Knoxville/Knox County Planning -- Historic Zoning Commission

Staff Report

File Number: 10-G-22-HZ

Exterior rehabilitation, removal and reconstruction of front and rear additions, new front porch.

1) SITE PLAN 1/16" = 1'-0"

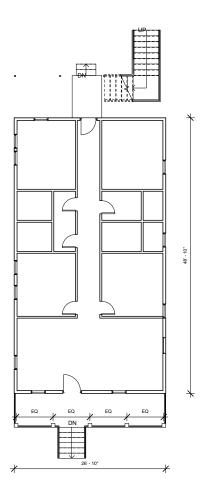
- 7. Final modifications to the site plan will be necessary to meet City Engineering standards for parking. The house and parking area need to remain below 45% impervious surface for the RN-5 zoning. The final site plan could be approved by staff, provided there are no substantial modifications to the addition's design and placement.

Staff recommends approval of Certificate 10-G-22-HZ, subject to the following conditions: 1) retention of existing eave overhangs and cornice return, use of appropriately-sized cornerboards, window trim, and door trim; 2) front door spec to be submitted to staff for approval; 3) final site plan to reflect City Engineering standards.
